Product hierarchy no. *				Part no.	SBU	Type / Description	Customer part no.
SBU	PG	PUG	Type				
02	007	012	0000002051	See list below	Connectors	Appliance Outlet 10A 6600-5	-

Product Change Notification					PCN 6600-5 - Change of Material, Production Site		
owner	creation date	release date	released by	change order no	rev	page	D10-028-655
vetersa	21.08.2018	20.09.2018	limachcl	2016104	A	1 of 2

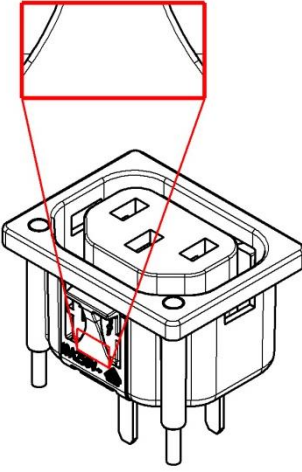
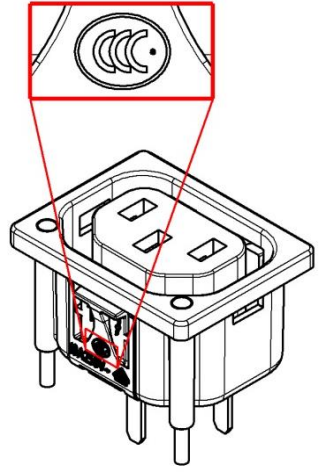
Old material Polyamid PA6/66	New material Polyamid PA6
Old appearance 	New appearance 
Old packaging label 	New packaging label

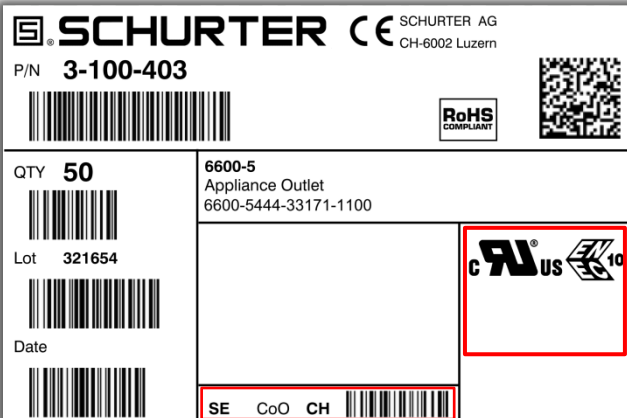
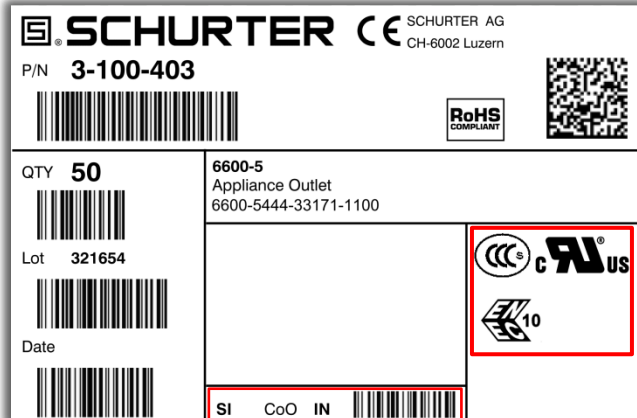
Form	Yes	Approval sign: CCC added to moulding part Appearance of front surface
Fit	No	No change for dimension
Function	No	No change in function
Manufacturing	Yes	Change of manufacturing site
Label	Yes	Approval sign: CCC added to packaging label
Packaging	No	No change in packaging
